# Access Compliance Report

## Public Rights-of-Way

Intersection ID: N/A	Main Street: SUMMERFIELD RIDGE LN	Cross Street: SUMMERGROVE CT	Location: SW
ADA ID: 7FC4001B689B	Ramp Type: PerpDiag	Initial Pass/Fail: Pass	Overall Compliance: No
Codes/Mitigation Info/Possible Solution			Severity Score: 15
			Field Measurements/Component Compliance

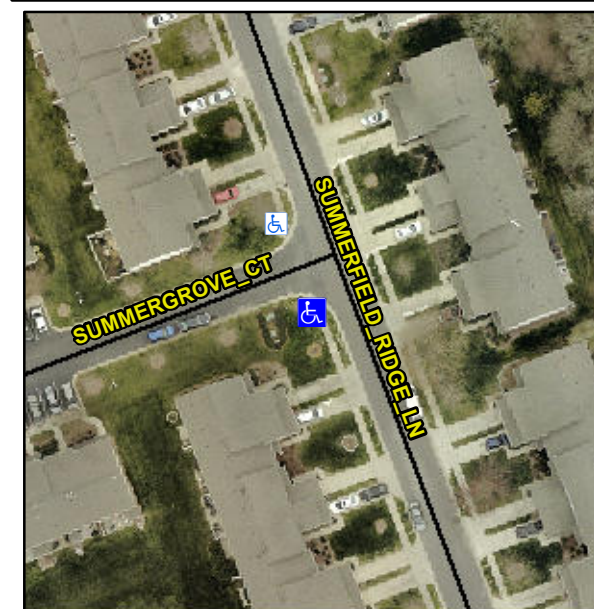
**Remove & Replace Curb Ramp With Two New Directional Ramps or Equivalent. Remove & Replace Gutter.**

**Not Found, R304.2.2-Perp, R304.3.2-Para, R304.5.3, R305.1.4, R305.2, R302.7.2, R304.5.4**
